DOCUMENT 009113.01 – ADDENDUM NO. 1

Project: Columbia County - 911 Call Center Addition

COLUMBIA COUNTY 911 CALL CENTER ADDITION
50 GRANDINETTI DRIVE
GHENT, NY 12075

G001

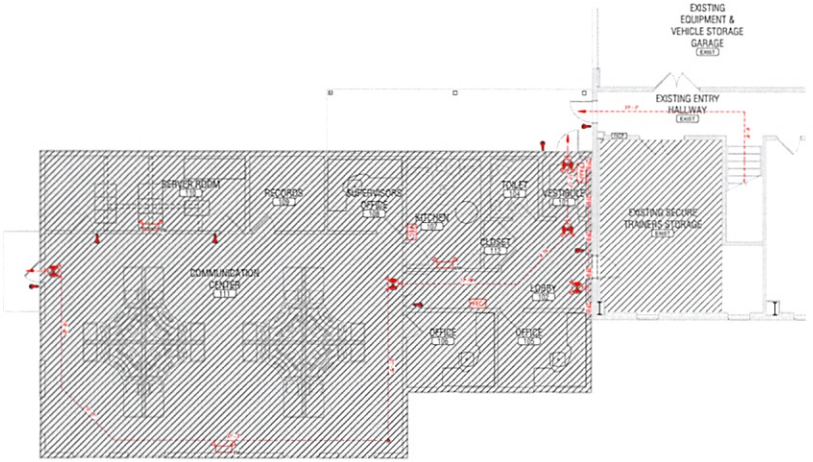
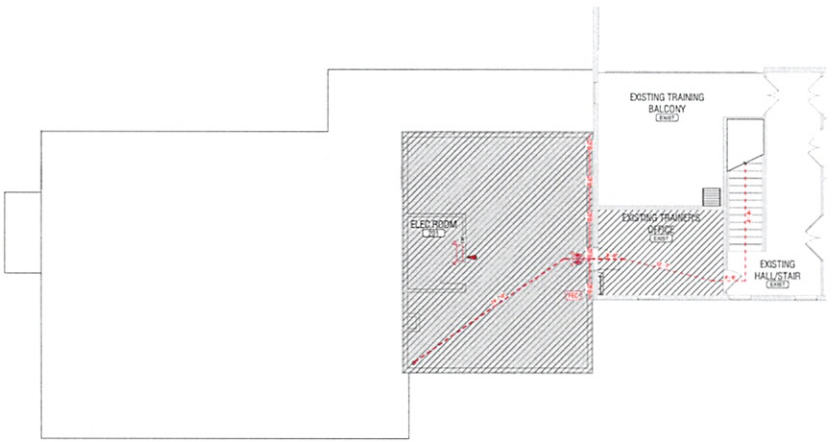
A. Drawing G001 Code Compliance and Life Safety Plan revised as follows:
   1. Added COMcheck & Existing Building Code Compliance Notes

DRAWING NUMBER:
A203

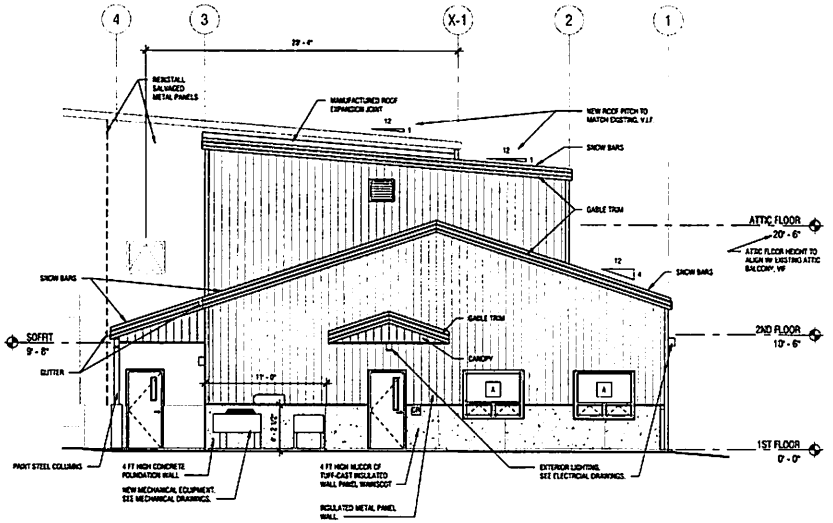
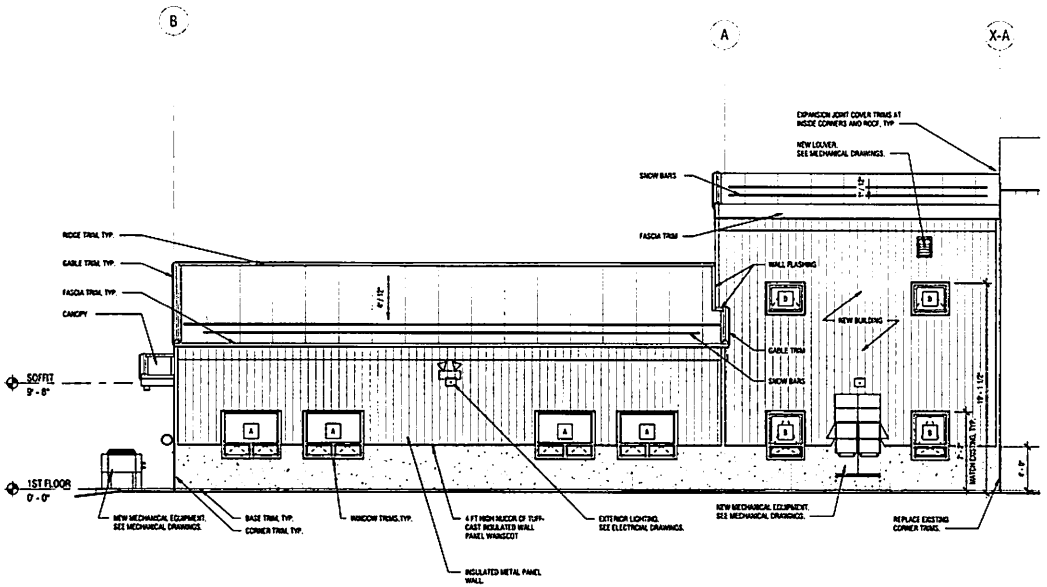
1. RFI: Drawing A203 Exterior Alterations - Alternate is listed on the drawing cover sheet but is not in the drawing set that was issued to bidders. Please provide.

a. RESPONSE: Drawing A203 included in attachments – reference Contract No. 1 Alternate No. 2.

5 A302 ACCESS FLOOR PANEL DETAIL
N.T.S.

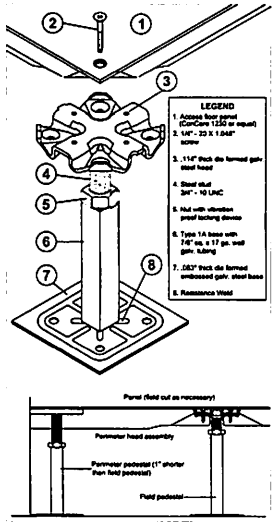
5. RFI: The Basis of Design access floor system is a Tate All-Steel 1250 access floor panel supported by a Posi-Lock Understructure. A Tate ConCore 1250 panel is suggested in lieu of an All-Steel 1250 in 911 Call Centers as the ConCore panel is cementious filled and reduces noise transfer inherent in a hollow steel panel.

B. Drawing A302 – Building Sections revised as follows:
   1. Added Detail 5/A302 Access Floor Panel Detail.

a. RESPONSE: Provide equivalent ConCore 1250 panel.

3 A601 ALUM. FRAME JAMB @ EXTERIOR
SCALE: 3" = 1'-0"

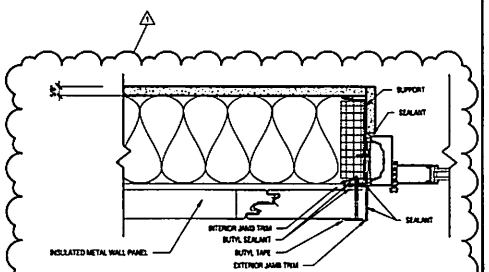
C. Drawing A601 Door and Window Schedules revised as follows:
   1. Revised Hardware Sets Updated on Door Schedule.
   2. Revised Jamb Details 2 & 3.
